**DAVID PLUMMER & ASSOCIATES**

June 3, 2015

**Re: Mediterranean Village Review - #14153**  
**Traffic Impact Study, Parking Analysis & Valet Operations Analysis**

HOTEL DROP-OFF - OPTION #3 “STAFF RECOMMENDATION”

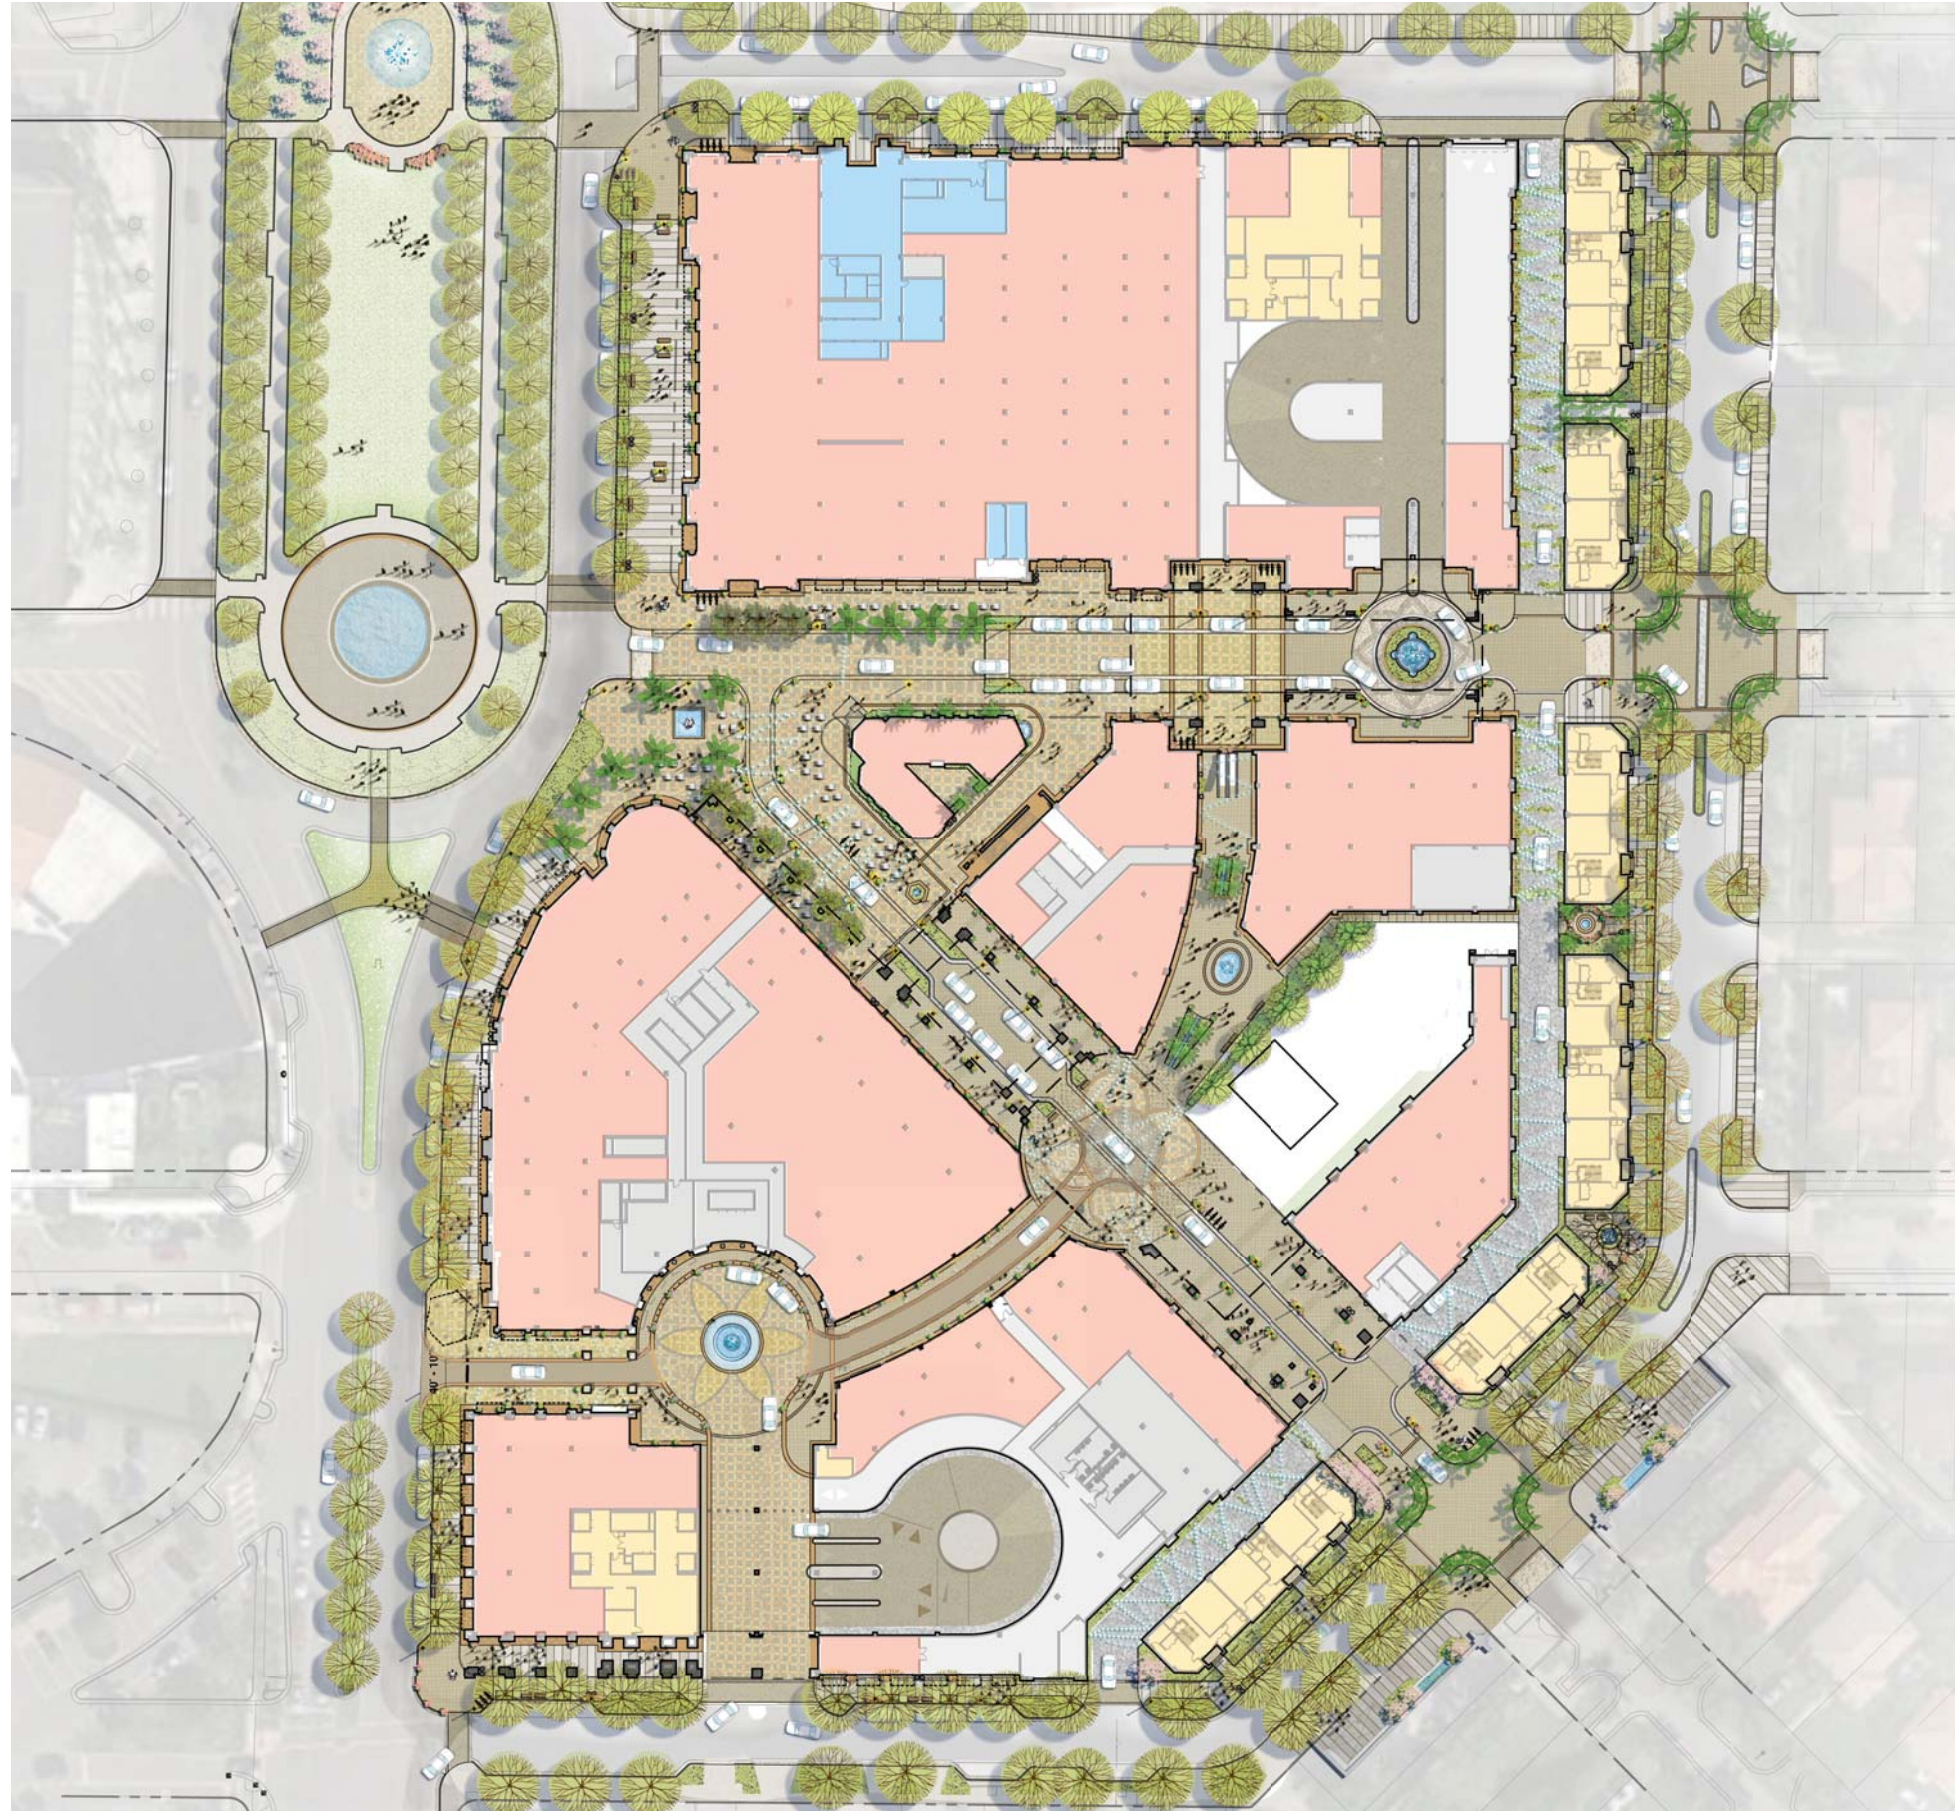
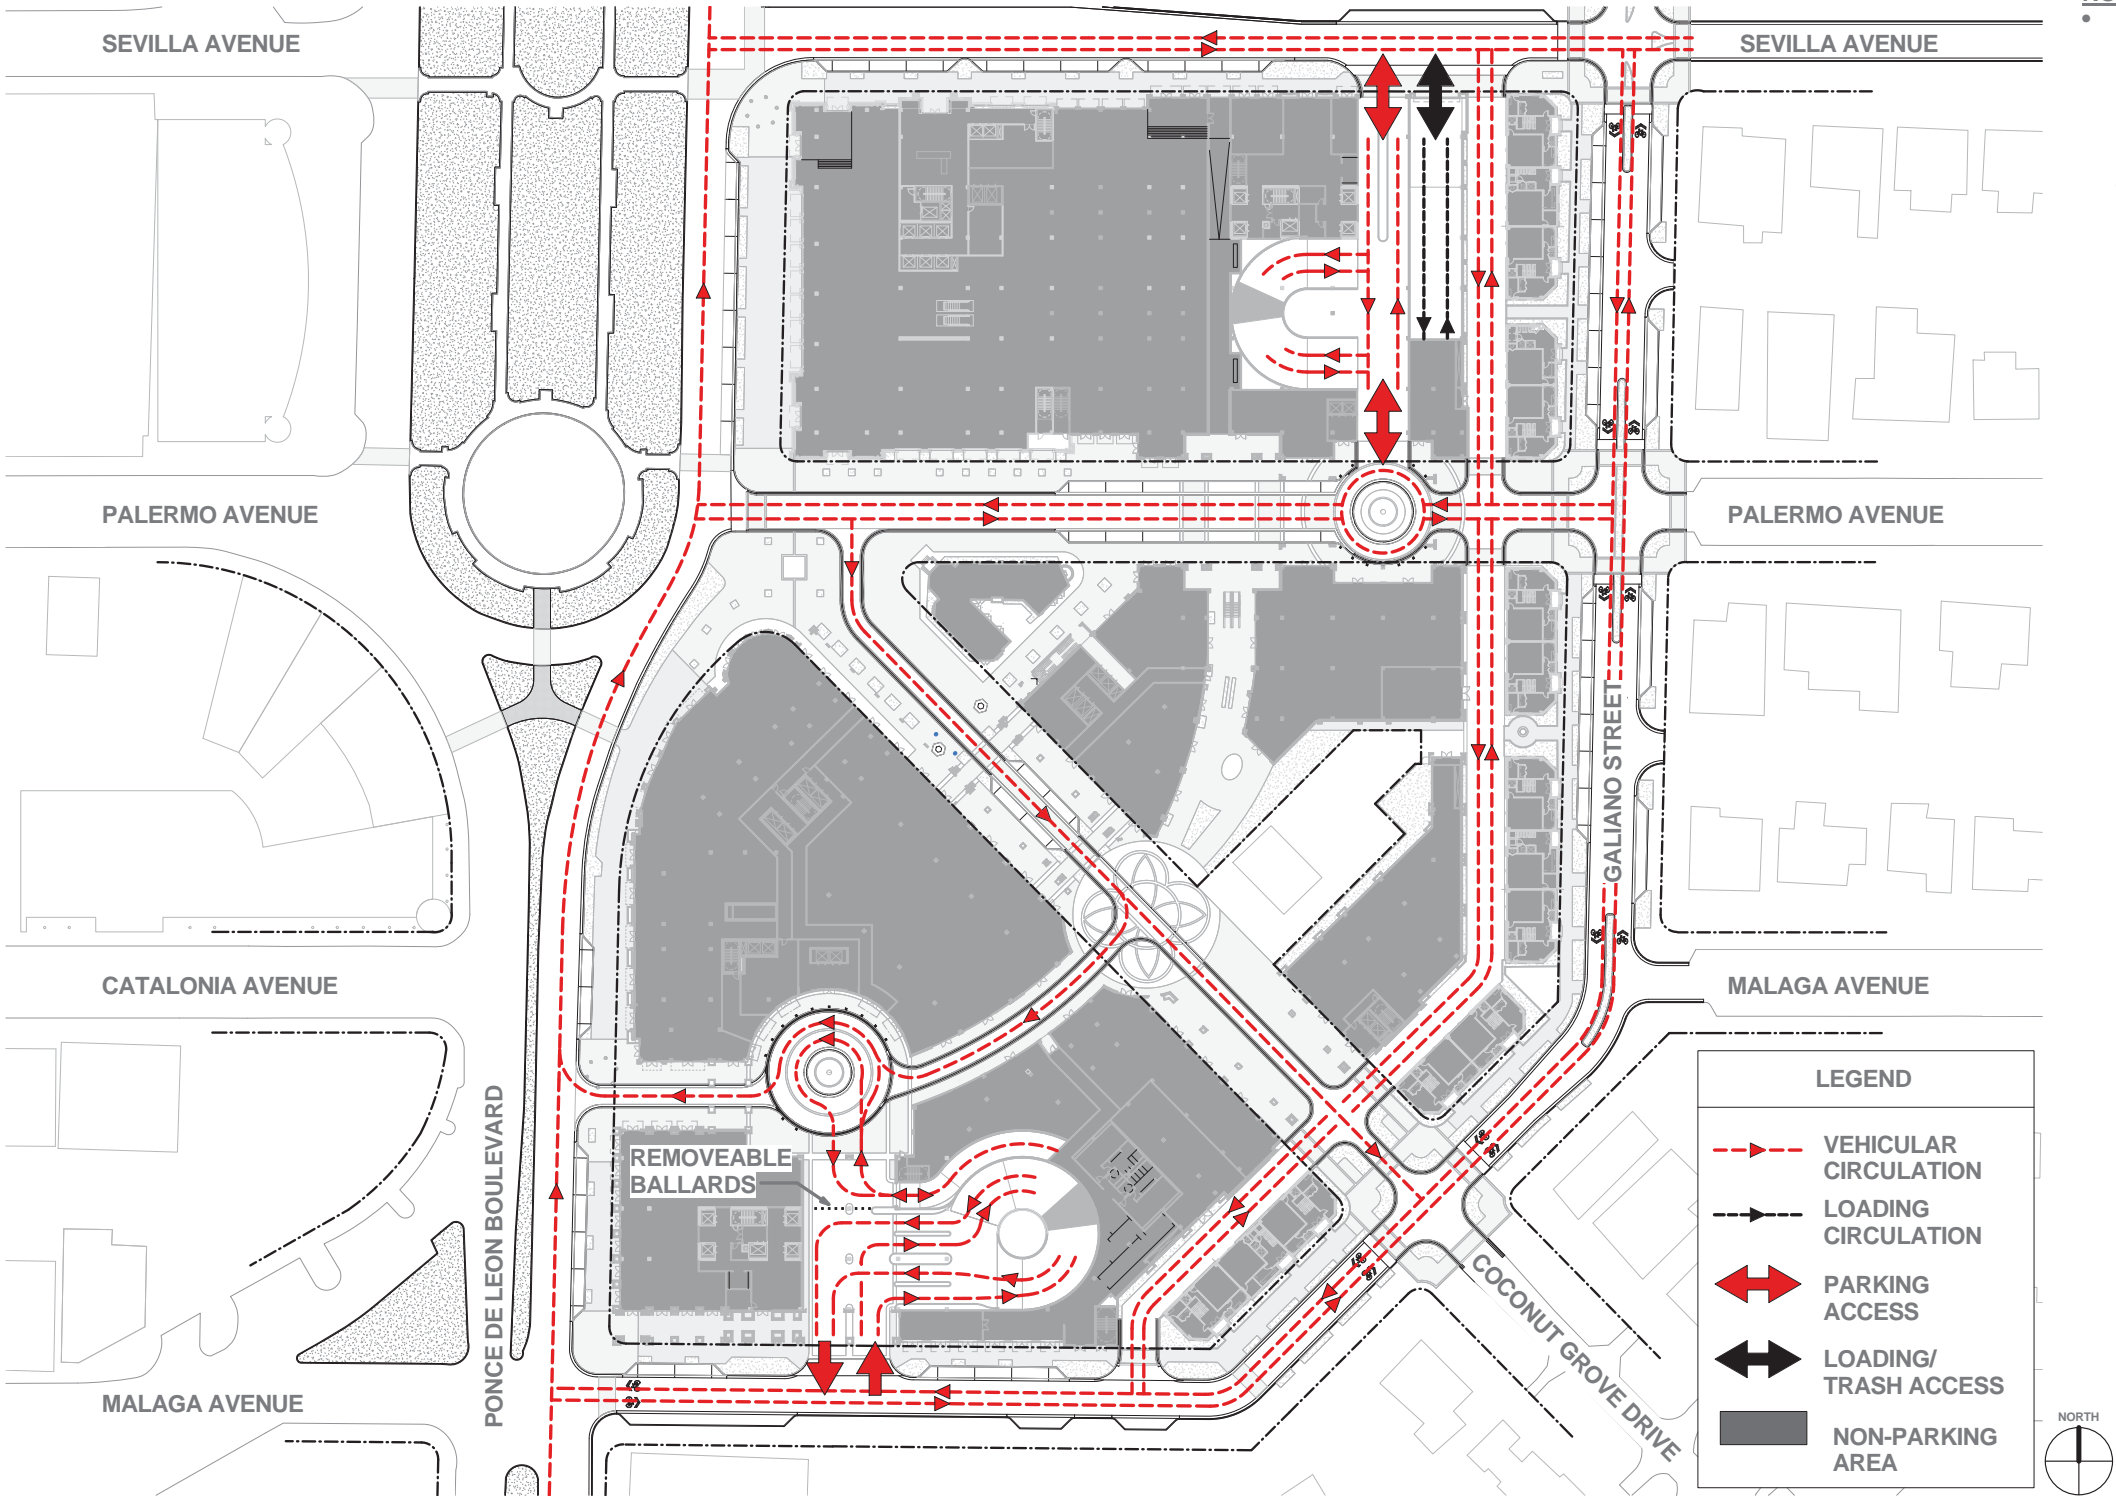
During first reading, the project included direct access to the hotel from Ponce. This access plan for the hotel was acceptable. The project has since changed to address comments from the Commission. Of the newly proposed options, Option 3 is an acceptable alternative and preferable to Option 2 provided that the following conditions are included: 1) the hotel valet ramps will be completely segregated from the Malaga driveway ramping system and no traffic from Malaga would be allowed to access the hotel's porte cochere, and 2) two one-way ramps (similar to the Ponce alternative) or a two-way, two-lane ramp for hotel valet use only is provided. See attachments for hotel access options.
